Technical Bulletin

Bulletin No: TCH-001-056

Subject: **New Gasket for Bendix® Inlet Check Valves (ICVs) Used for BA-921™ Compressors (Detroit Diesel Applications)**

FIGURE 2 - New Components

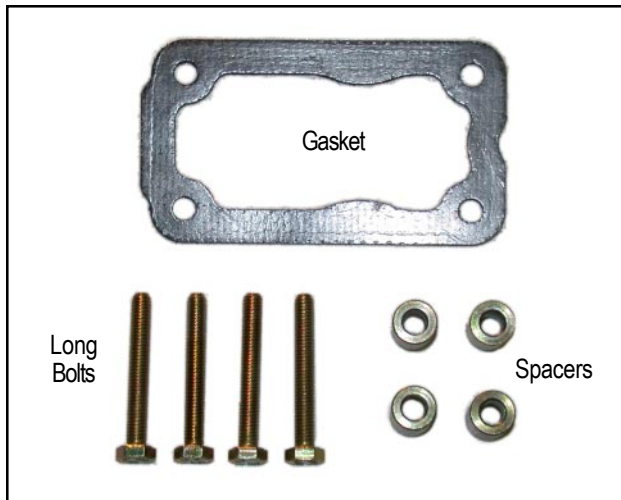
All new orders for service replacement ICV assemblies will feature the new gasket, spacers and longer bolts.

FIGURE 1 - Comparison Showing New Gasket

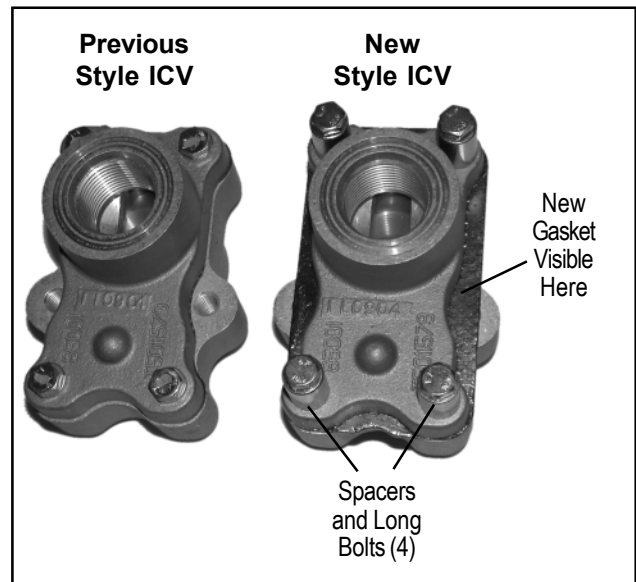
As a product improvement for the Bendix Inlet Check Valves (ICVs) used for BA-921™ compressors, Bendix is now implementing a new gasket design and material as a running change in all assemblies and kits.
